September 22, 2015

RE: Submittal of Response to EPA and TCEQ July 2015 Comments on Feasibility Study
Patrick Bayou Superfund Site – Deer Park, TX

Aug 31, 2015 5:17pm tgriga K:\Projects\0284-Patrick Bayou Joint Defense Group\Patrick Bayou 2013\0284-RP-012_PELQ_307.dwg Exhibit 3

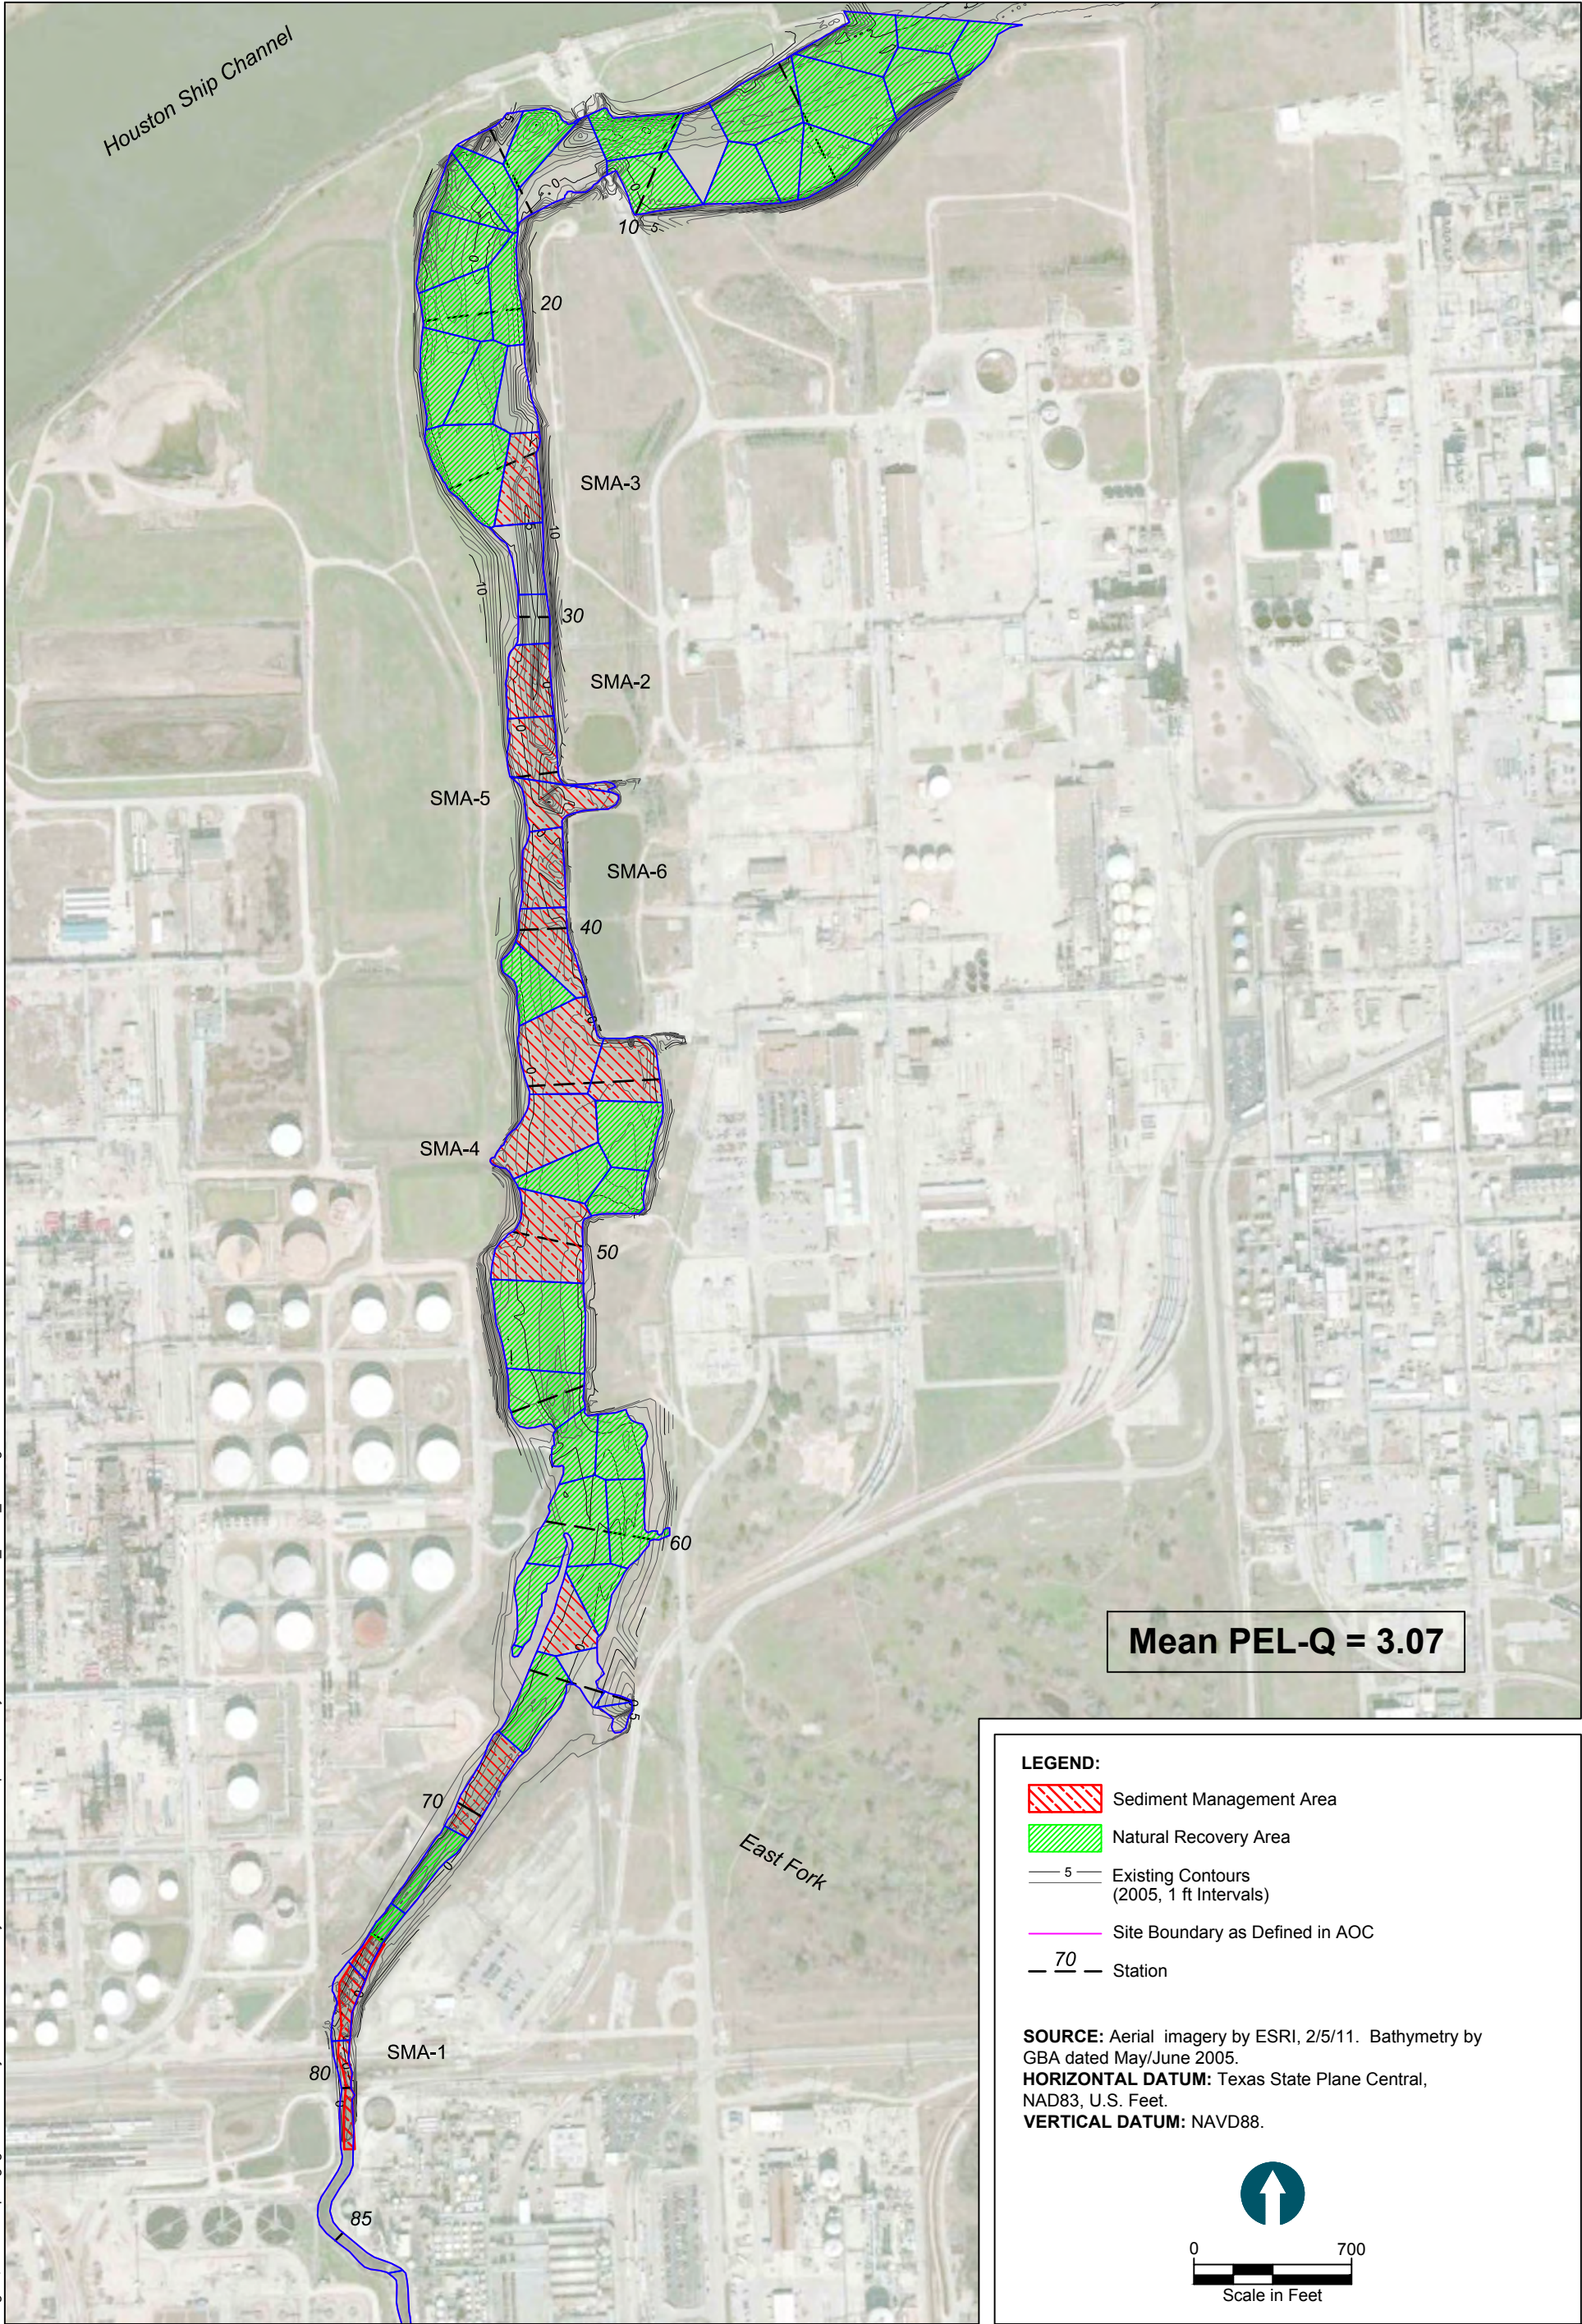
Second, the probable effects level quotient (PEL-Q) issue has not been resolved. While we prefer a target PEL-Q value of 3.07, we are willing to consider the compromise PEL-Q value of 4.47, depending on our evaluation of the additional information requested below.	As previously documented, the probable effects level quotient (PEL-Q) value of 3.07 is not supported by the data or analysis presented in the U.S. Environmental Protection Agency (USEPA)-approved Baseline Ecological Risk Assessment (BERA). TCEQ’s comments on the Draft Feasibility Study (FS) Report dated December 19, 2014 states a preference for the sediment preliminary remediation goal (PRG) to be set at a mean PEL-Q of 3.07 to represent the lowest mean PEL-Q for any station

⁸ Note that, consistent with the above response regarding the applicability of the mean PEL-Q of 3.07 as a sediment target value, Exhibit 3 is provided for comparison only and is not considered a relevant sediment target value.
